**RE: Creekside PA23-005 Technical Review 1 – Response to Comments**

Please refer to our responses below which address all review comments received from the City of Marysville on May 8th, 2023, regarding the Creekside BLA submittal package. You will find the markup comments listed in the order that they were written followed by our response in *italics*.

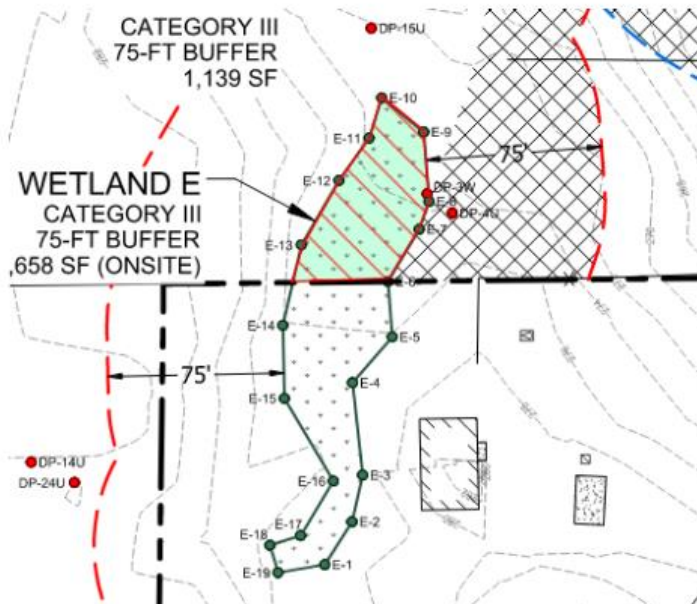
27. The Critical Areas Report identifies portions of Wetland E that are on the project site (hatched in red below), yet it is not depicted on the site plan. Buffers associated with Wetland E are not depicted on the site plan. It appears that if Wetland E and its associated buffers are depicted in their entirety that the buffer would extend into Road B and lots 24-27. It does not appear that these impacts have been addressed. Ending the wetland at the property line with no buffers is not consistent with MMC 22E.

**Response: The Conceptual Mitigation Plan has been updated to show the portions of Wetland E that are located onsite. The buffers of Wetland E are not depicted on the site plan because the onsite portion of Wetland E is proposed to be filled in order to accommodate required road access from the east. No onsite buffers for Wetland E are warranted because the offsite indirect impacts to Wetland E have already been accounted for within the Conceptual Mitigation Plan.**
